[Docket No. 2002-NE-19-AD; Amendment 39-13693; AD 2004-13-11]

Airworthiness Directives; Rolls-Royce plc RB211 Trent 875-17, Trent 877-17, Trent 884-17, Trent 884B-17, Trent 892-17, Trent 892B-17, and Trent 895-17 Series Turbofan Engines

ACTION: Final rule.

Vertical Fin-Skin Panelling
Figure 1

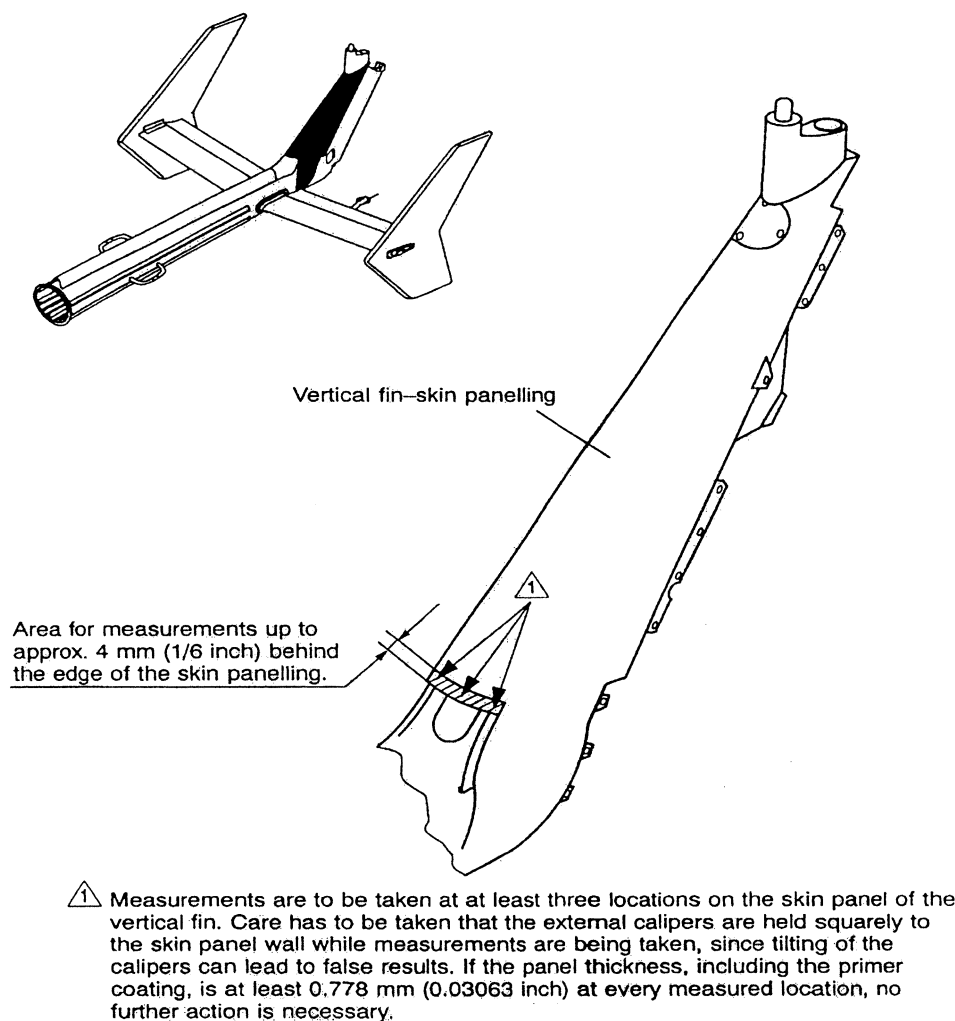
(b) If the wall thickness, including the primer coating, of the paneling is less than 0.778 millimeter (0.03063 inch) at any of the measured locations, replace the vertical fin with an airworthy part before further flight.
